**NOTICE OF A REGULAR MEETING
BONDURANT PLANNING AND ZONING COMMISSION
JULY 11, 2024**

TITLE: Public Hearing - Considering recommended approval of a rezoning from A-1 Agricultural District to Medium Density Residential (R-2) District and Transitional Commercial (C-1) District on Parcels 231/00021-632-000 and 231/00072-330-000.

TITLE: RESOLUTION NO. PZ-240711-21: Considering recommended approval of the site plan at 2502 Robinson Avenue NE.

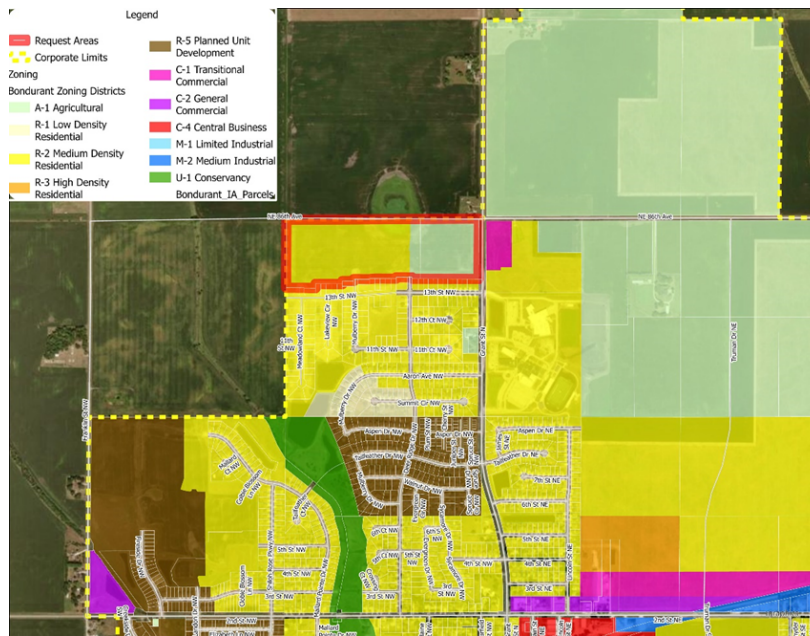
Zoning – The majority of Parcel 231/00072-330-000 is currently zoned as R-2 Medium Density Residential. The applicant is proposing to rezone the remaining portion of the property to R-2 Medium Density Residential, as well as the majority of Parcel 231/00021-632-000 to R-2. The exception is the northeast corner of Parcel 231/00021-632-000, near the intersection of Grant Street N/NE 72nd Street and NE 86th Avenue, which is proposed to be rezoned to C-1 Transitional Commercial. The R-2 District allows for low-density residential, which currently exists to the south in Sankey Summit Plats 2 and 3. The C-1 Transitional Commercial allows for low-intensity retail commercial, office commercial uses, and medical office commercial uses.

FILE PATH	J:\2024 Projects\24-023 BIP Lot 4 Site & Building Plans\Engineering\Site Plan\Sheet Set	C-101 - LAYOUT SHEET
-----------	---	----------------------

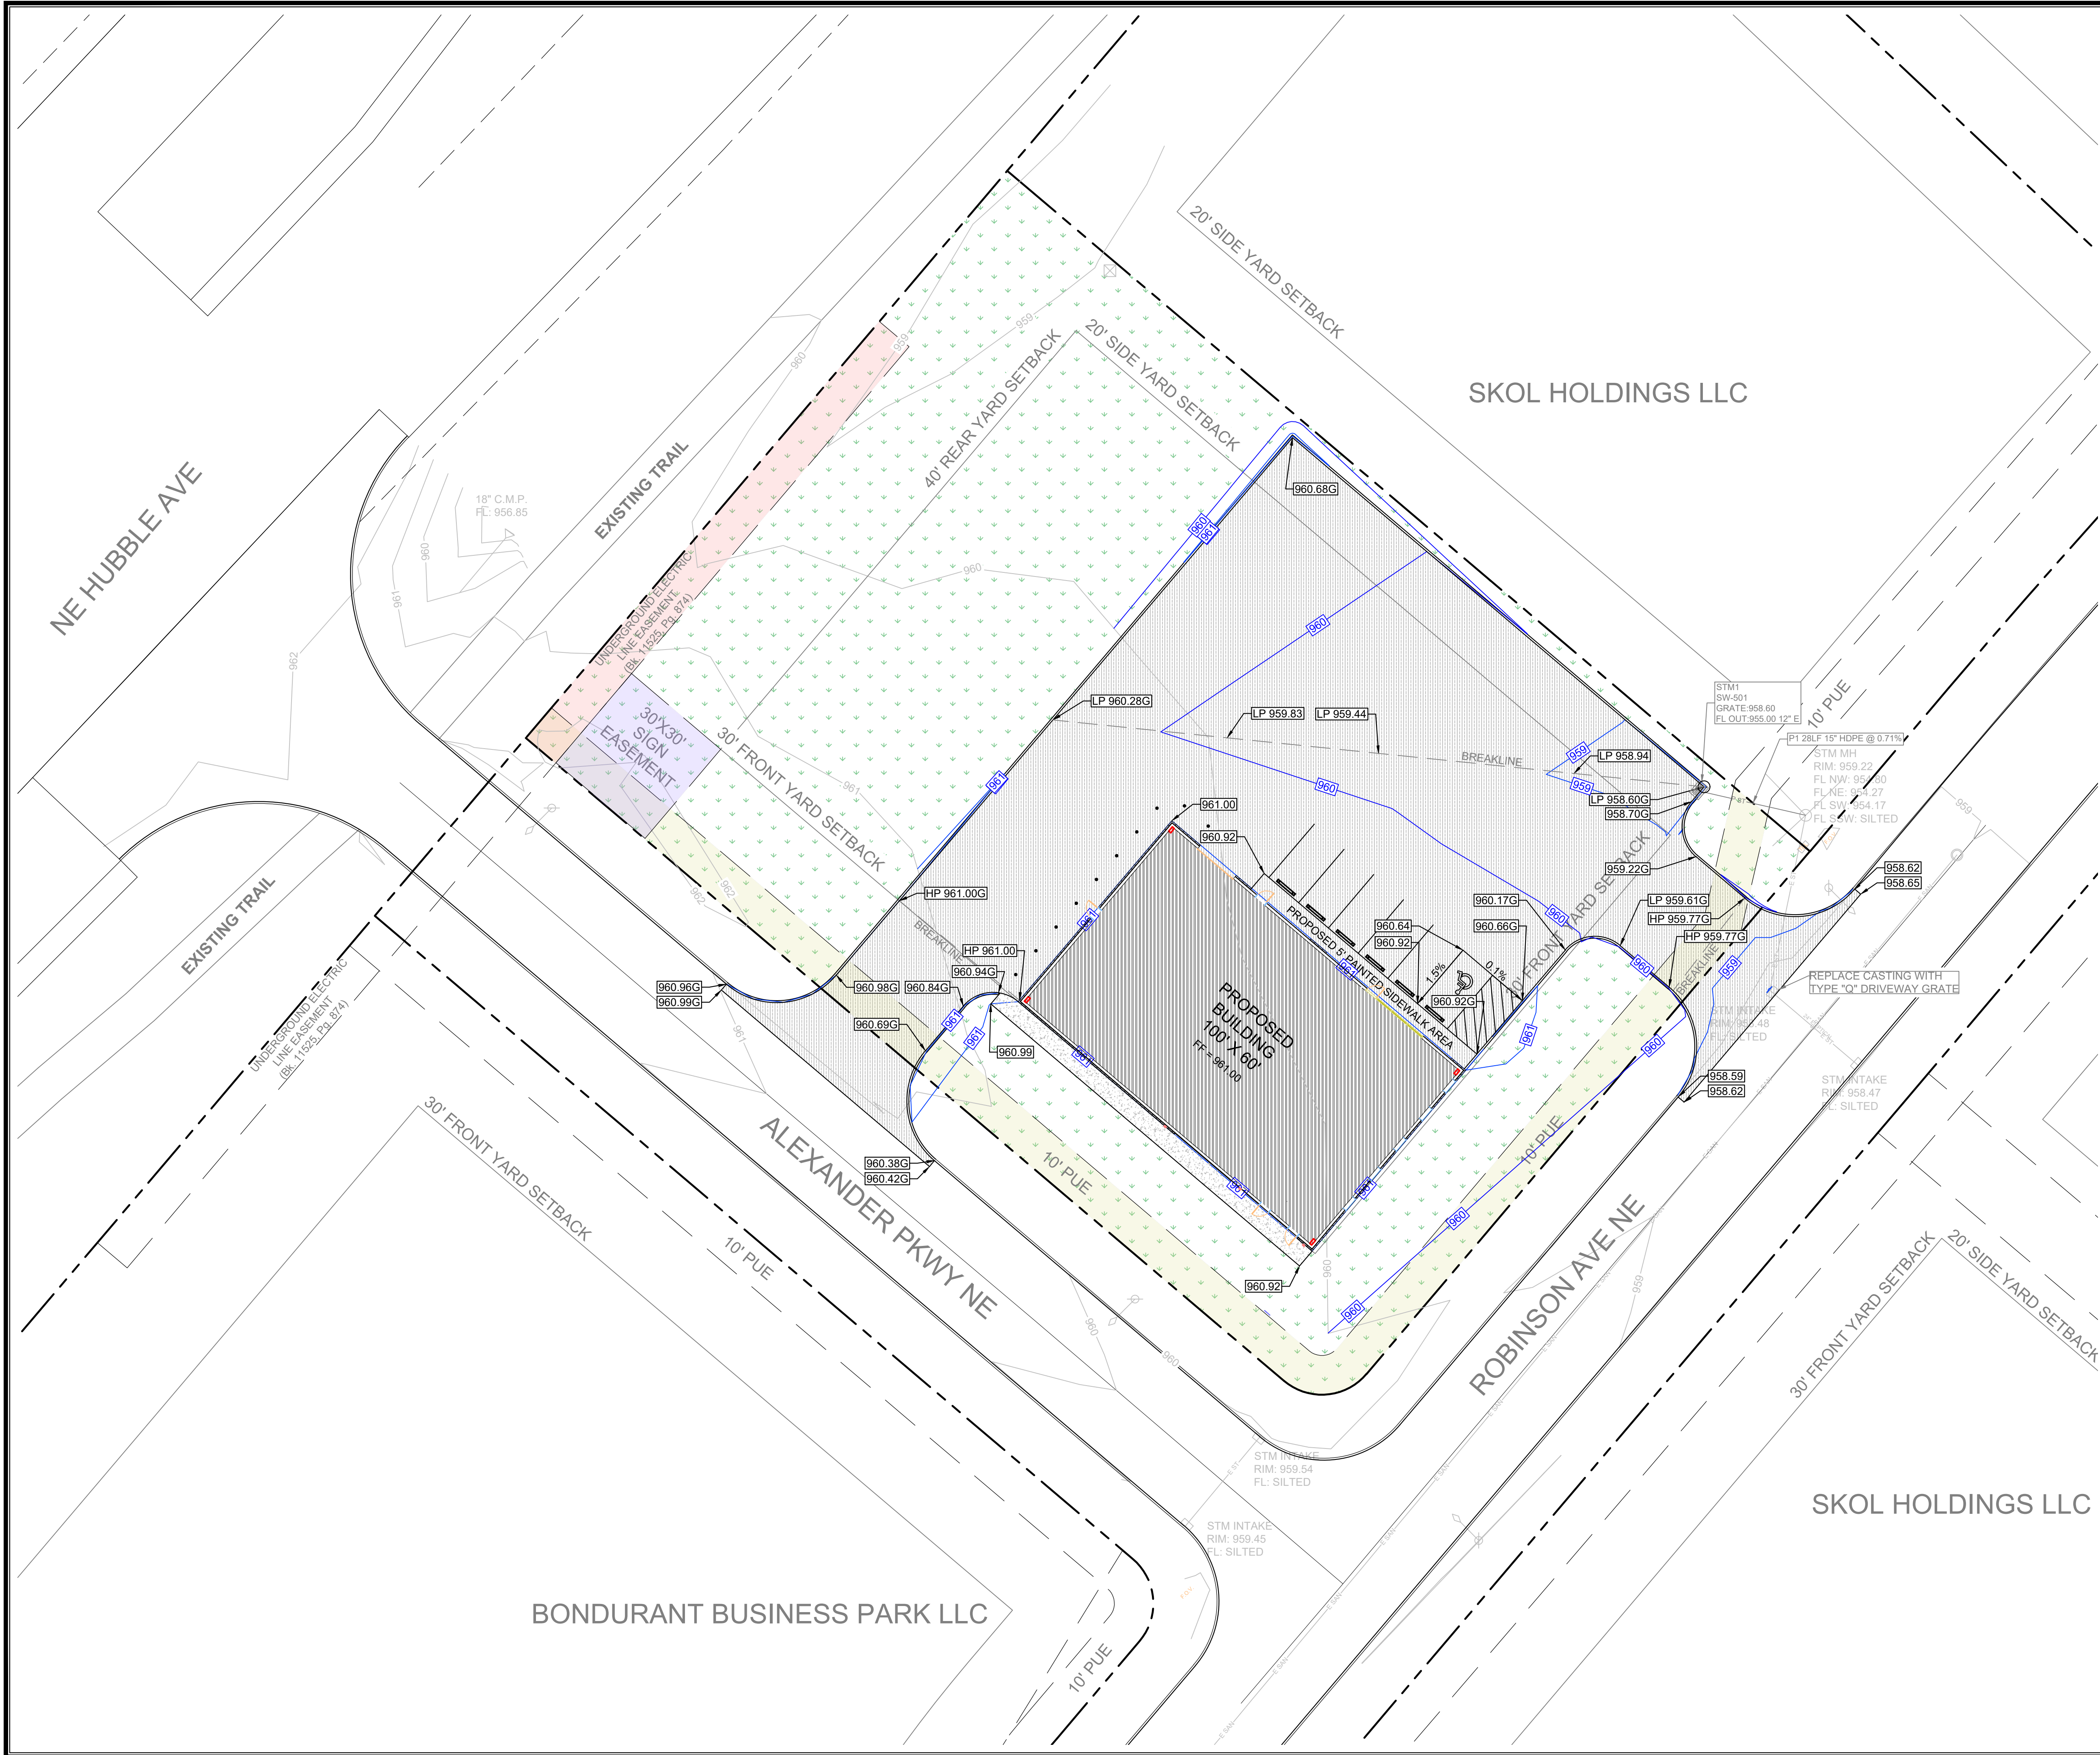
- The site plan labels the required setbacks at this location - a 30' front yard setback along Robinson Avenue NE and Alexander Parkway NE, a 40' rear yard setback along the northern property line and 20' side yard setback along the northeastern property line.
- The site plan shows outdoor storage area. Staff has requested additional information regarding square footage of the proposed outdoor storage area. Surface materials for the outdoor storage area will require to be updated.

- Access to the site is proposed from Robinson Avenue NE and Alexander Parkway NE. Public Works and Engineering are still reviewing if this is acceptable.
- The site plan shows 5,671 square feet of warehouse space. The site plan shows 6 parking spaces, 1 being a handicap parking stall. The site plan states the site requires 1 space per 200 square feet of gross floor area. Based on the use of the property, staff believes the site requires 1 parking space per employee. Staff has requested additional information to clear up this issue.
- The site plan shows the parking/drive/loading area as being at least 10' from right-of-way lines.
- The site plan shows all parking/drive/loading areas as 6" P.C.C. which meets code requirements.

- The site plan shows parking spaces will be provided with raised curbing or equivalent, as is required by Section 177.10.8. on page 11 of the submitted site plan.
